Subject: J-Coach ESP/ABS Pressure Sensor Rework			
Field Change Program: Field Campaign	FCP Number: 472	Revision: A	Date: 01/21/2020
Coach Section: 07- Electrical	P/N: N/A		Type: Product Integrity

Coach Model	Model Year	VIN
J4500	2018 - 2019	68377 - 69514
J3500	2019	68877, 68909, 68935, 68965, 21000 - 21030

5.0 Correcting pressure sensor electrical connections

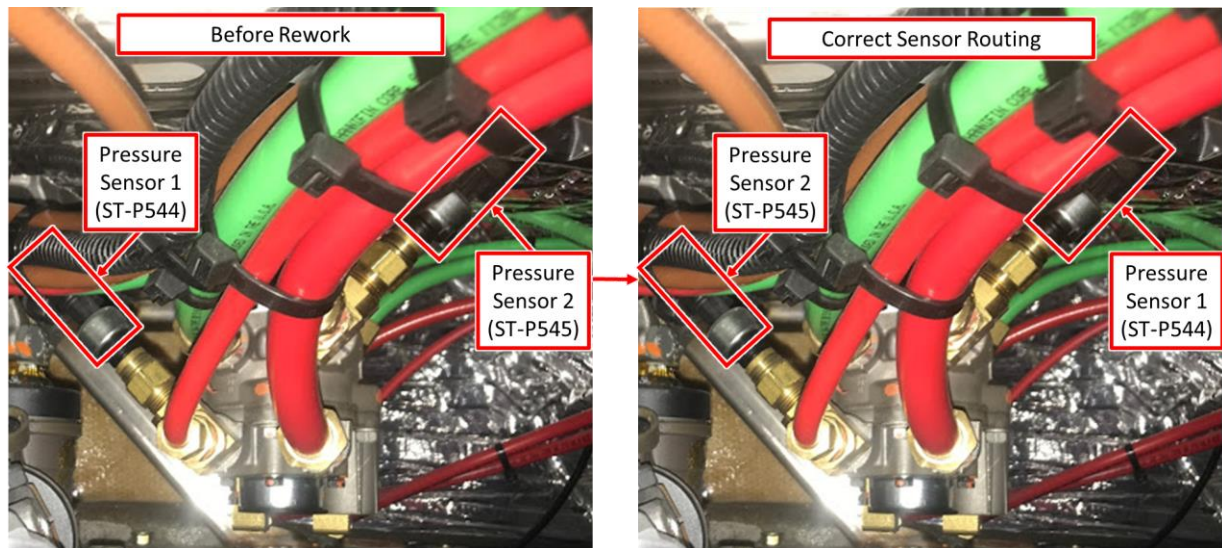
The Bendix ESP/ABS pressure sensor electrical connectors (ST-P544/ST-P545) were reversed during installation.

Under the driver's floor in the FJB, locate the two pressure sensors on the pedal assembly fittings. Ensure the electrical connector labeled ST-P544 is connected to pressure sensor 1 and the electrical connector labeled ST-P545 is connected to pressure sensor 2 on the ESP/ABS Bendix harness. Pressure sensor 1 is connected to the green air delivery hose and pressure sensor 2 is connected to the red air delivery hose.

Remove both electrical connectors labeled ST-P545 and ST-P544. Connect the electrical connector labeled ST-P544 to pressure sensor 1, green air delivery hose, and the electrical connector labeled ST-P545 to pressure sensor 2, red air delivery hose. Secure both sensor wires with zip ties as needed.
